1. Fountainhead MPUD A Request to Approve a Mixed Use Planned Unit Development Agreement for the 25-Acre Parcel Generally Located at Center Avenue and Walker Street.

MEETING DATE: February 22, 2017
FROM: Thomas Harowski
SUBJECT: Fountainhead MPUD A Request to Approve a Mixed Use Planned Unit Development Agreement for the 25-Acre Parcel Generally Located at Center Avenue and Walker Street.
NUMBER: (ID # 1603)
APPLICANT: Michael Woods, Cobb & Cole
PLANNER: Thomas Harowski

FOUNTAINHEAD
MIXED USE PLANNED UNIT DEVELOPMENT (MPUD)
DEVELOPMENT AGREEMENT

Walker Street Buffer Elevation

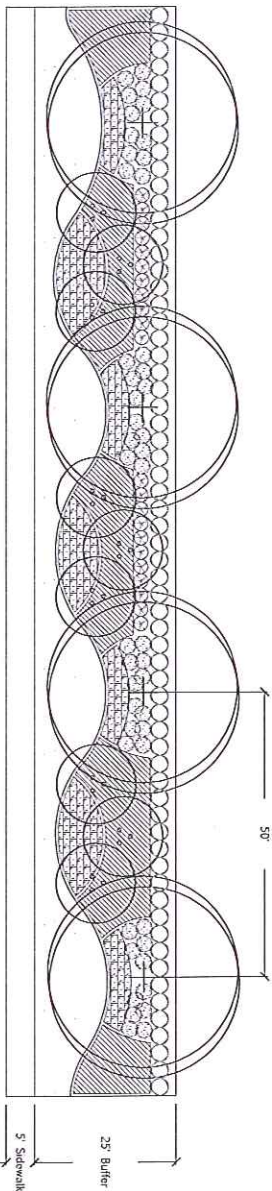
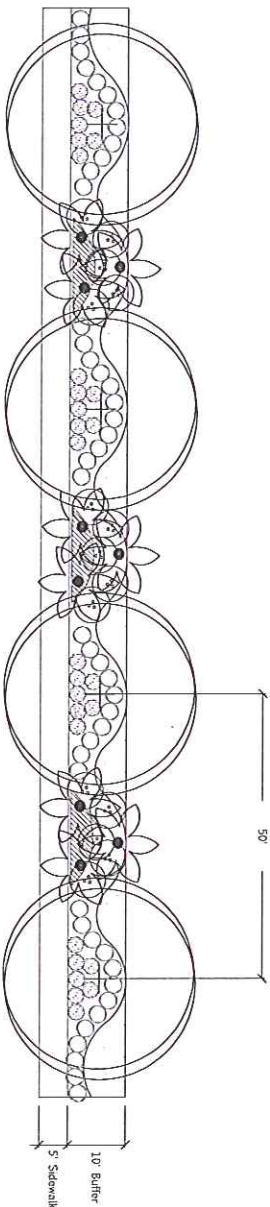
Commented [TH26]: This means the minimum buffer is 25 feet when drawing shows 25-feet. A larger buffer should be provided along Center Avenue and Walker Street as the frontages are where the highest impacts to adjacent parcels will be incurred. The wider buffer will allow trees to be closer to the interior side of the buffer and thus avoid the need to minimize impacts from overhead power lines.

Commented [TH27]: More discussion is needed on the reduction from 25-feet to 10-feet. If the intent is to use retention ponds to add landscaping and depth to the overall buffer effect, this may be acceptable, but I would like to see these linked more clearly. For Parcel 4, the Walker Street buffer should remain at 10 feet since that parcel does not have a retention area to support a smaller buffer.

Commented [TH31]: The retention ponds should of the landscape plan and not a reason to reduce the sc plan. The location of the ponds offers the opportunity trees south of the ponds to keep them removed from th overhead utilities and to use the area north of the pond understory trees and ground level landscaping. This s project is an opportunity to do a knock-out plan rather reason to knock out plant material.

- ii. This MDP provides for a landscape perimeter buffer of 10 feet along Walker Street. The minimum landscaping required for these areas shall be as provided on Page 2 and Page 6 of the Landscape Plan, attached hereto and incorporated herein as Exhibit "D". Additionally, as stormwater retention ponds are constructed in the areas adjacent to Walker Street, landscaping, as provided for on Page 5 and Page 6 of the Landscape Plan, attached hereto and incorporated herein as Exhibit "D", shall be incorporated into the design of the ponds. It is the express intent of all parties that the landscaping for the pond in Parcel 3 be consistent with and otherwise mirror the landscaping for the pond in Parcel 2. Please note that additional landscaping along Walker Street shall be provided for Parcel 4, as described immediately below.

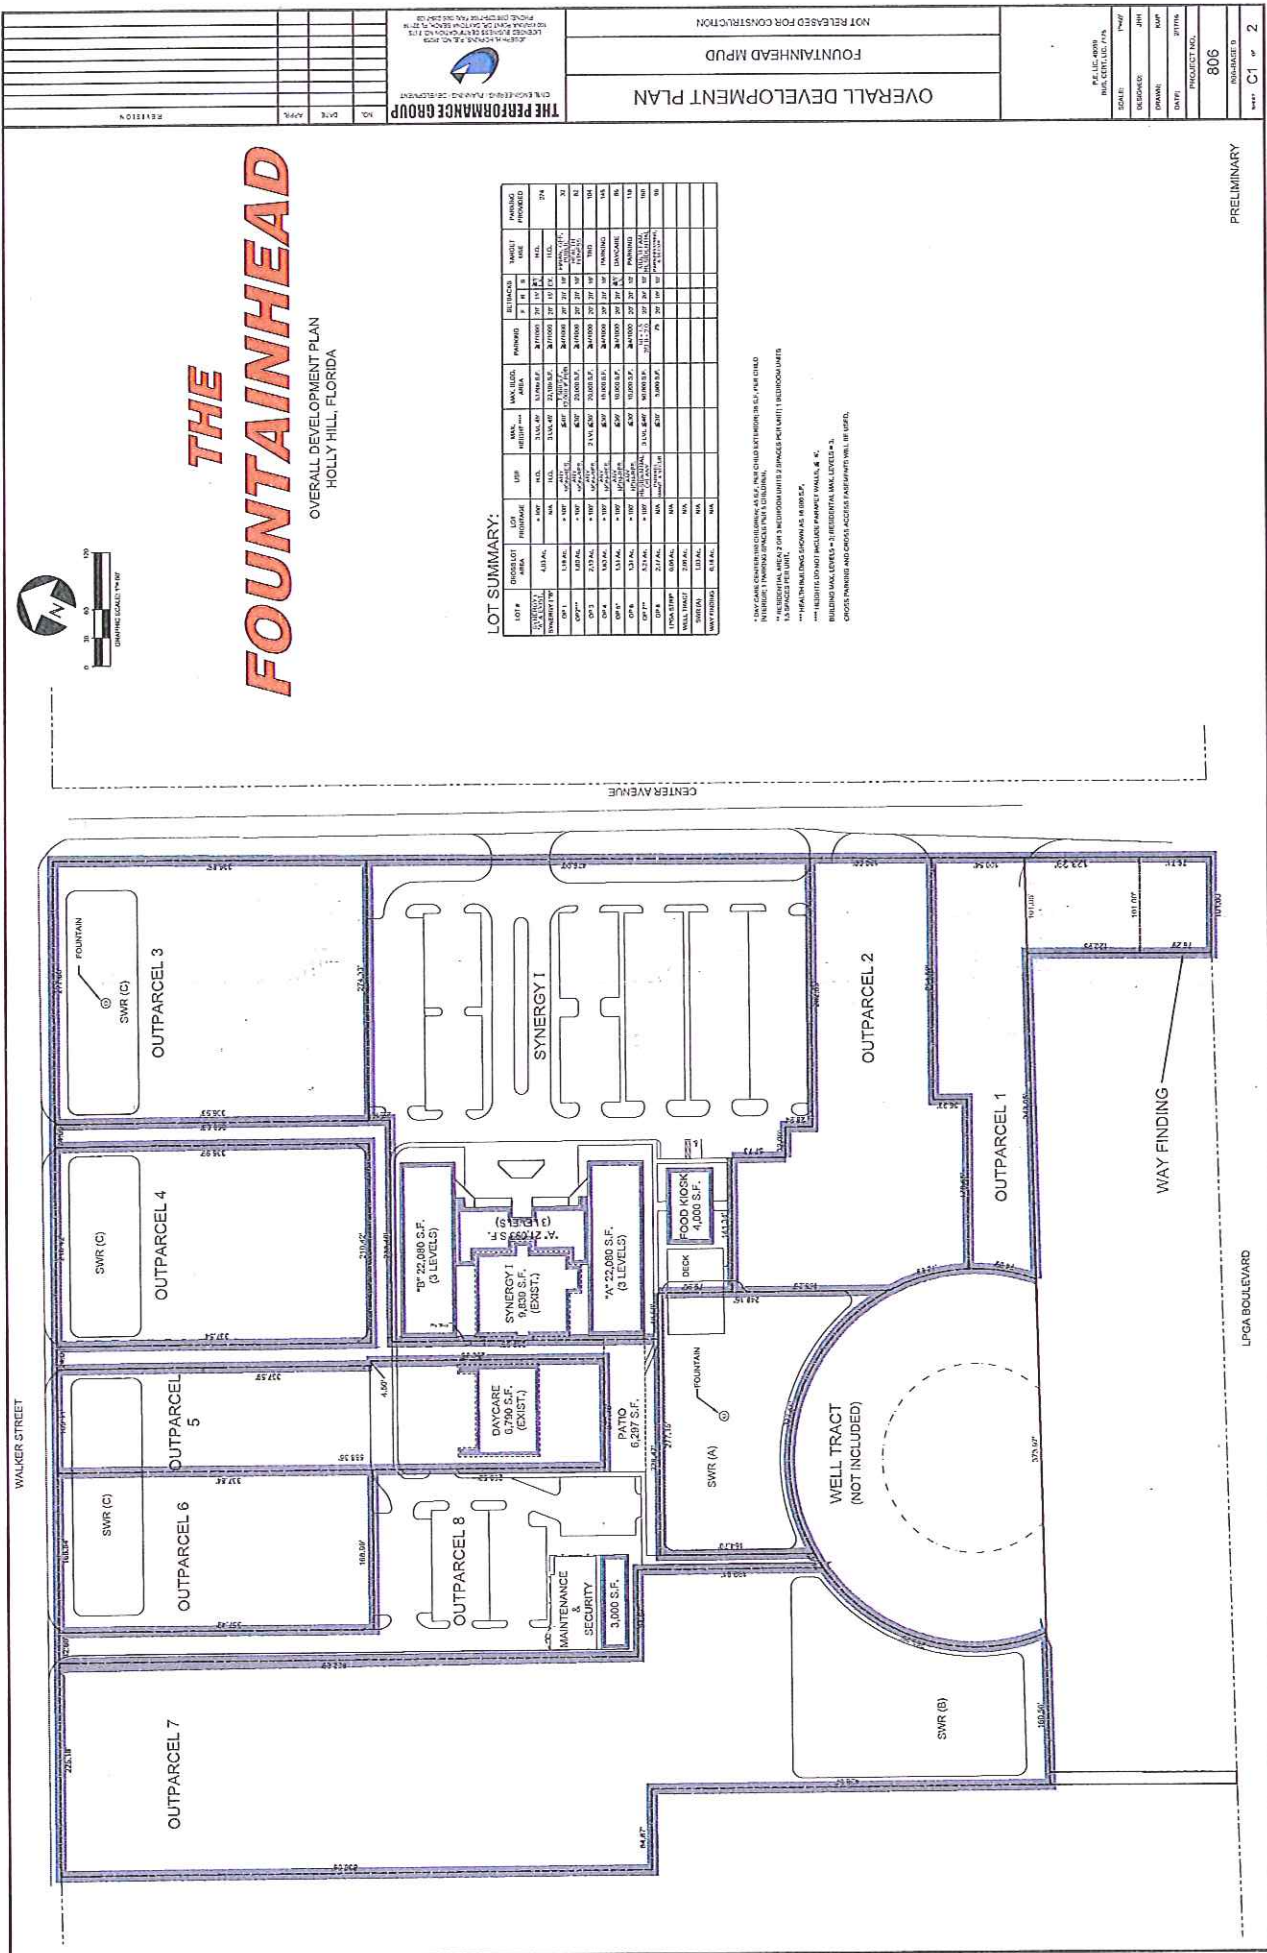
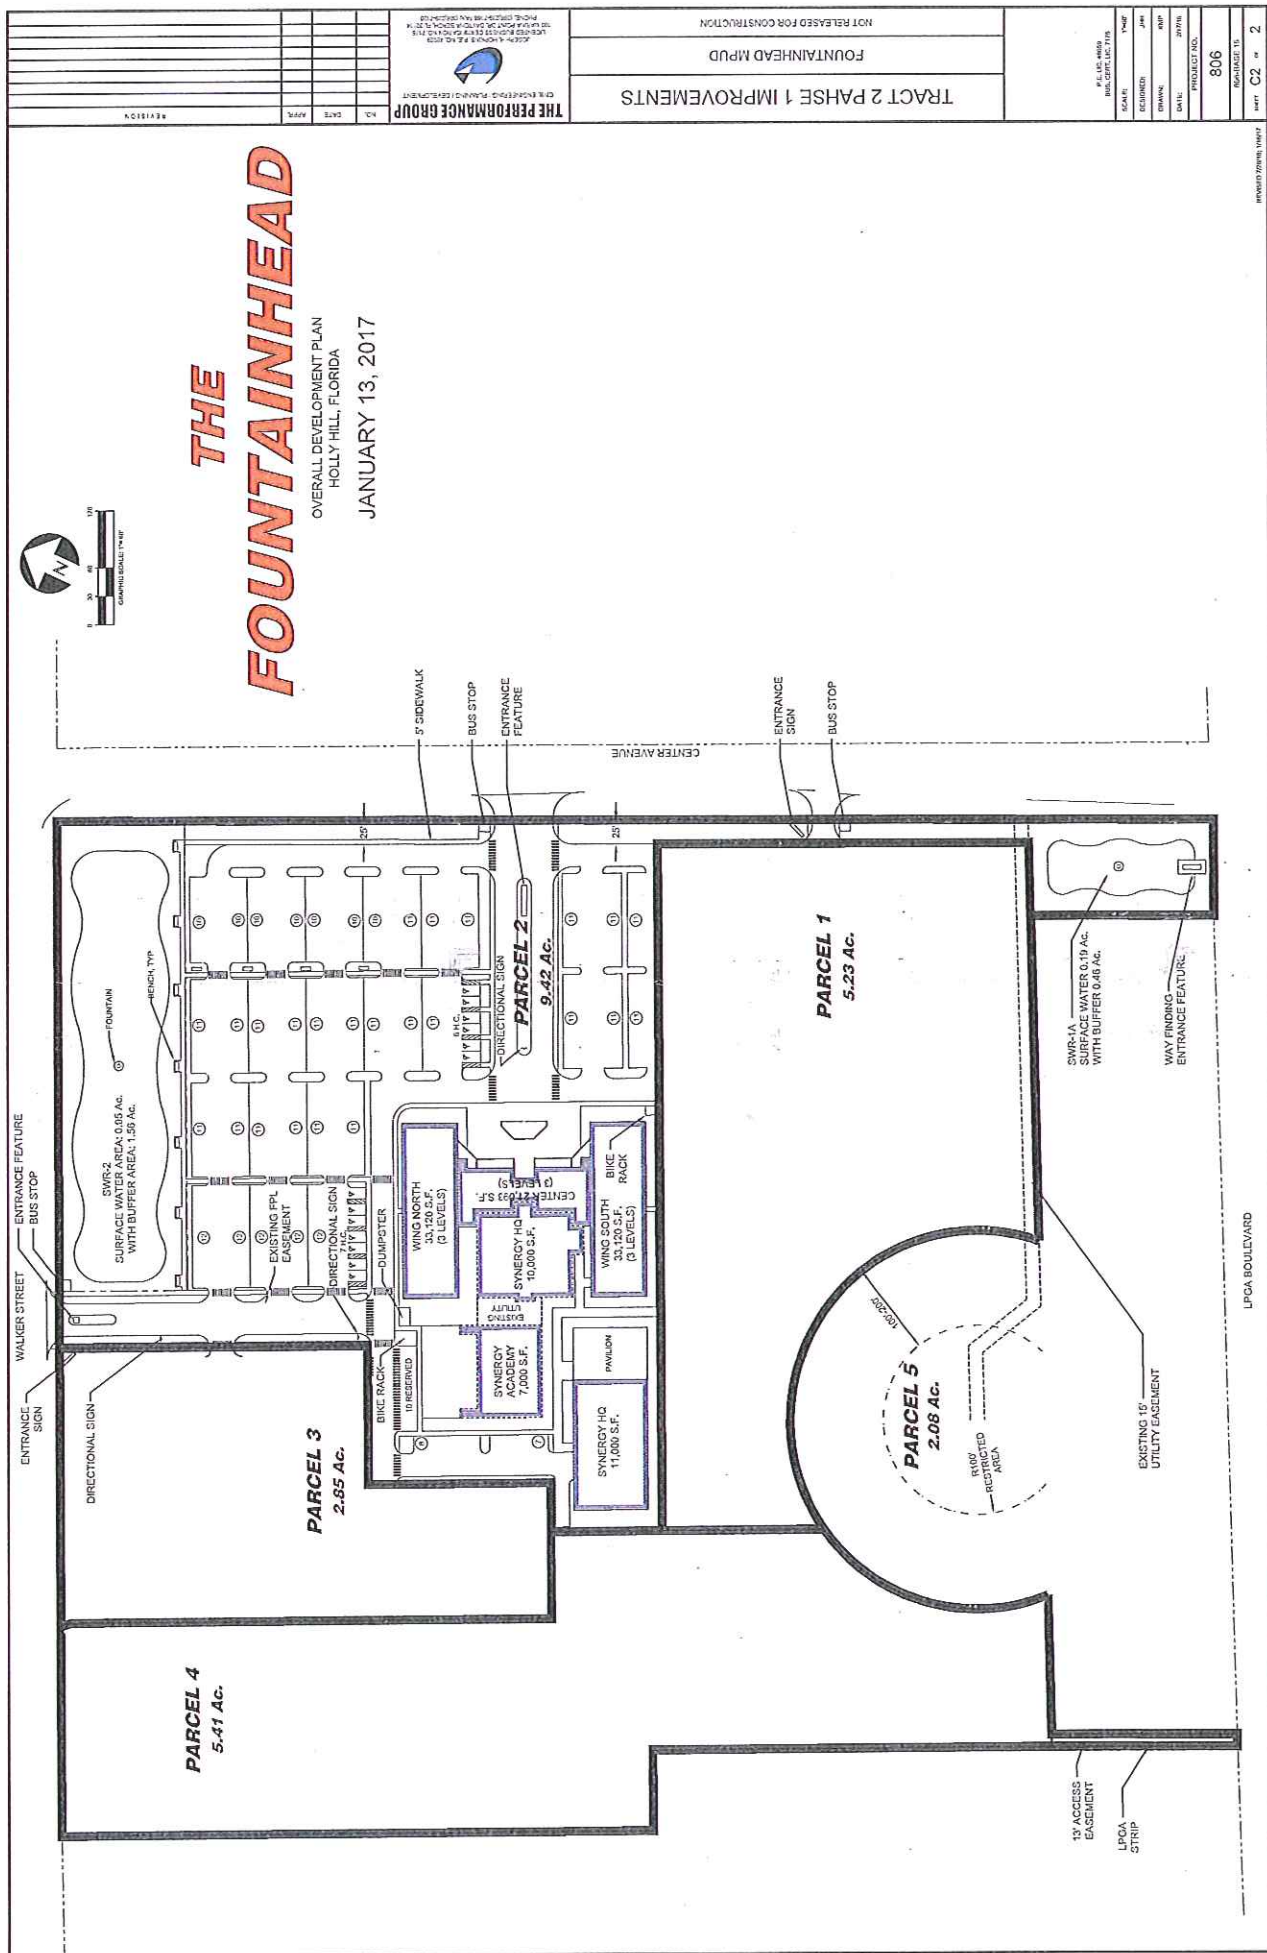
4. Figure 3, the Trip Distribution graphic is confusing and very difficult to read. The percentages you presented during the meeting were difficult to discern from the existing graphic. This figure needs to be revised to more clearly display trip distribution.

Exhibit G
HQ Architectural Elevations

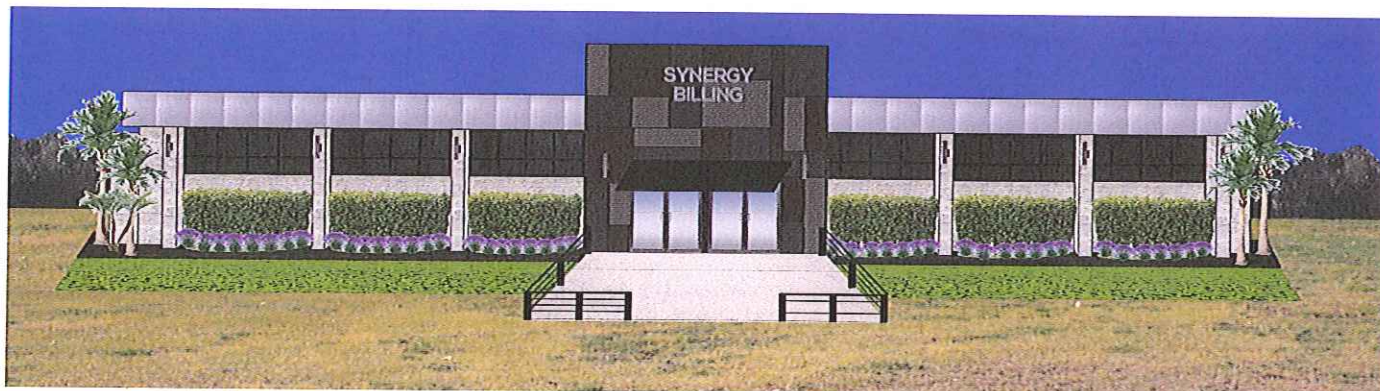
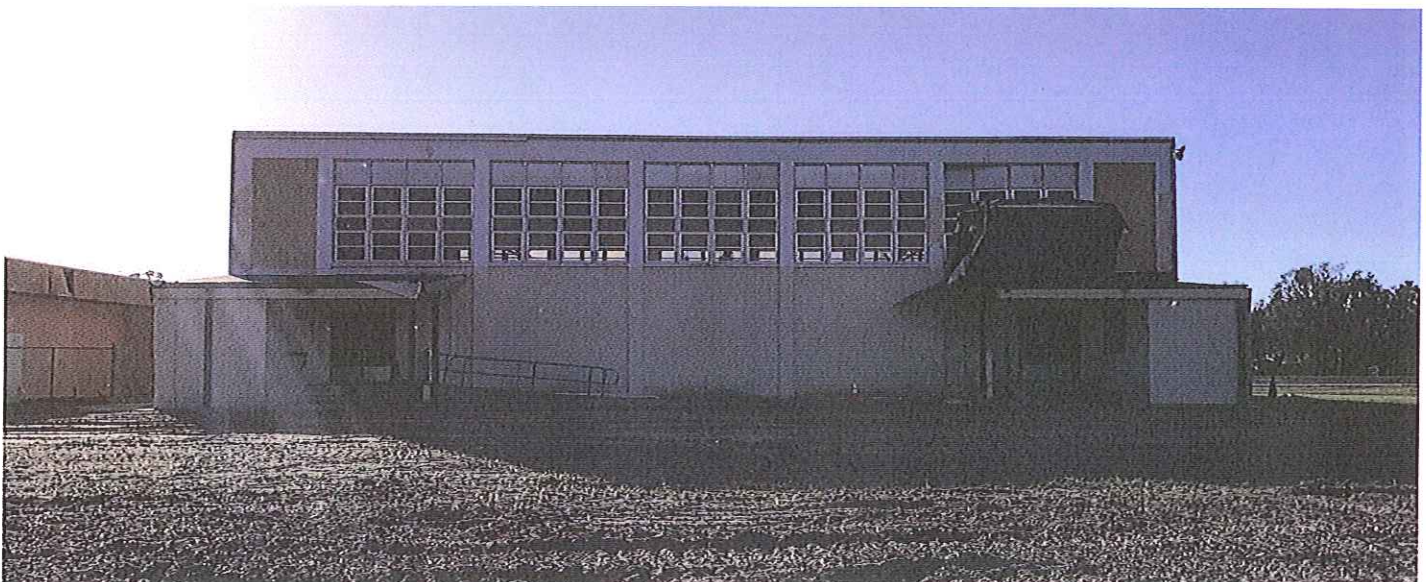
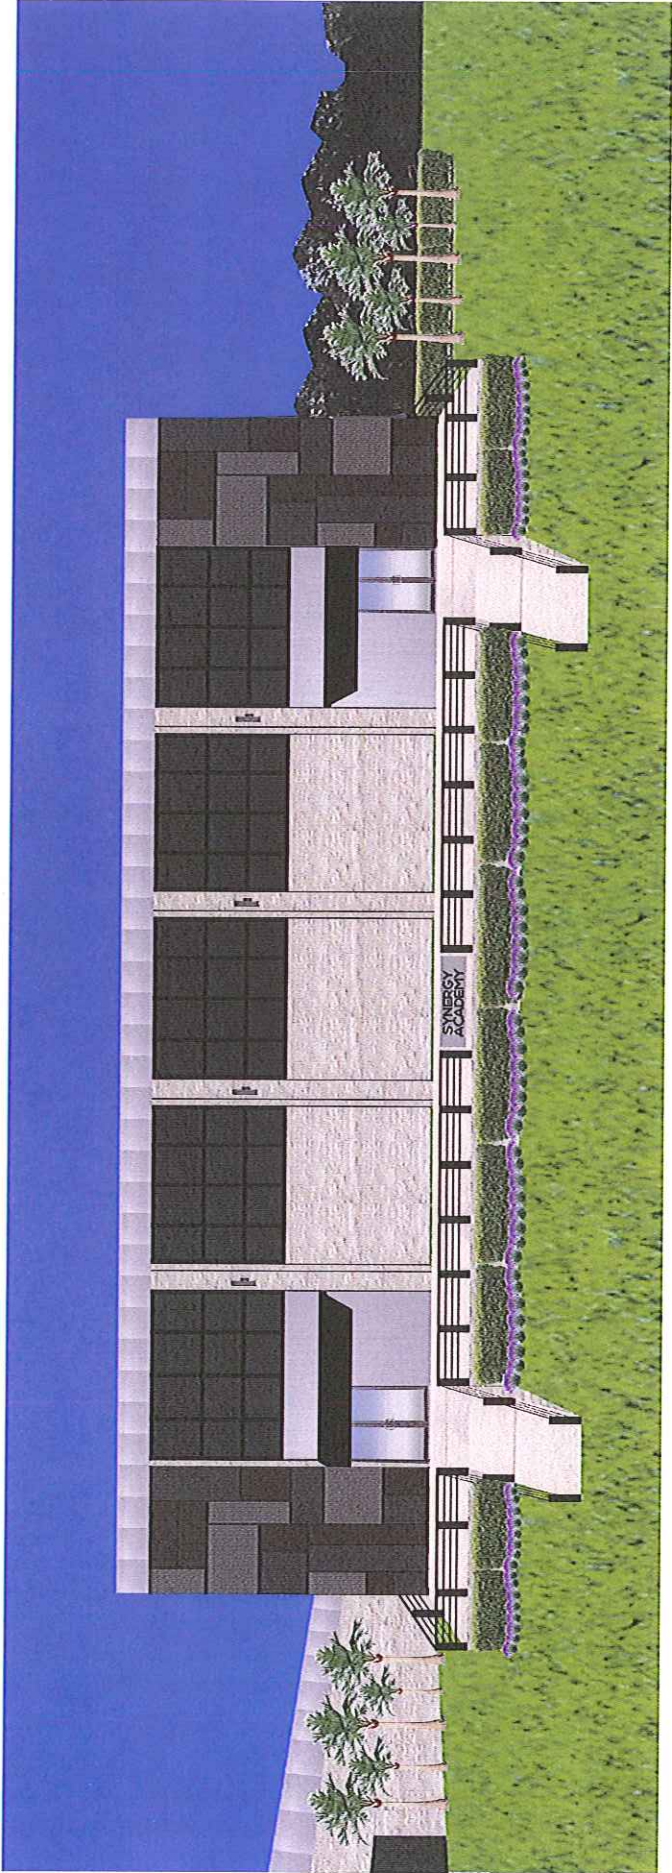
DESIGN CRITERIA	HQ BUILDING	ACADEMY BUILDING	NEW BUILDING
Flat Roof	Complies	Complies	Complies
Reflects Grid System	Complies	Complies	Complies
Ribbon Windows	Complies	Complies	Complies
Rectangular Shapes in Non-symmetrical Alignment	Fails	Partial Compliance	Partial Compliance
Rectangular Shapes with Cantilevered Elements	Can't Tell from View	Can't Tell from View	Can't Tell from View
Smooth Exterior Surfaces	Partial Compliance Except for Covered Brick	Partial Compliance Except for Covered Brick	Complies Unless Covered Brick is Used
Metal Detailing	Complies	Complies	Complies
Glass Exterior Wall	Partial Compliance	Partial Compliance	Complies
Vertical and Horizontal Relief	Likely Complies; Need alternate View to Confirm	Likely Complies; Need alternate View to Confirm	Likely Complies; Need alternate View to Confirm
